# Service-Information

BMW MOTORRAD GMBH Techn. Kundendienst R-VK-11 ma/ur	Motorcycles R90/6 - R90S Group: Engine	Munich, June 1978 11 006 78 (1045R)
---	---	--

Subject: Cylinder Head Locating

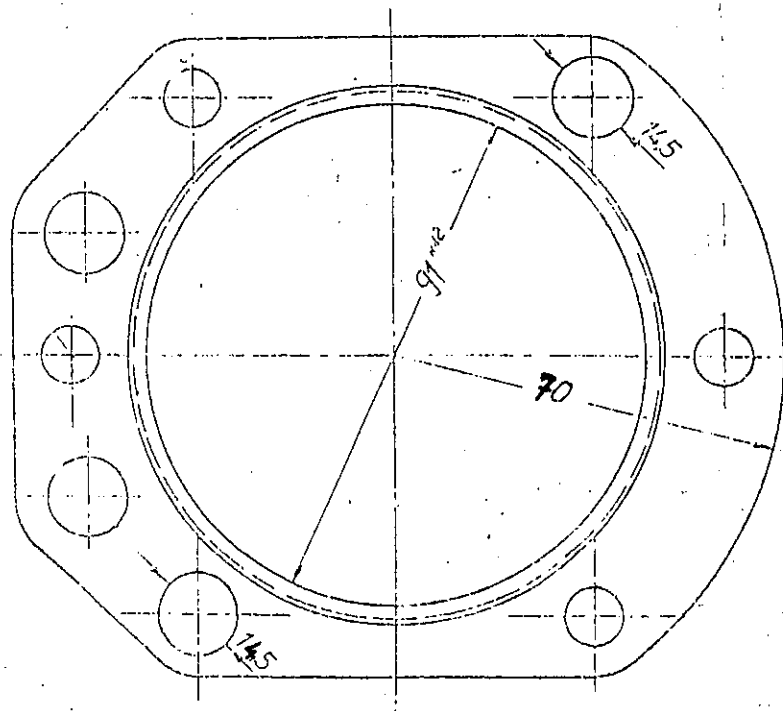
R 90/6	V.I.N.	4 961 244
R 90 S	V.I.N.	4 980 480

the countersink in the cylinder head and locating sleeve in the cylinder barrel

Part No. 11 11 1 258 311

are no longer manufactured.

At the same time, the head gasket corresponding holes were reduced to 10.5 - 11 mm diameter, all 6 holes are therefore identical.

The older head gasket, as per drawing, is no longer available.  
The new gasket

Part No. 11 12 1 261 672

could be used as follows:

Heat up the cylinder to remove the locating sleeves or enlarge the corresponding holes from 10.5 - 11 mm to 14.5 mm.

See above drawing.
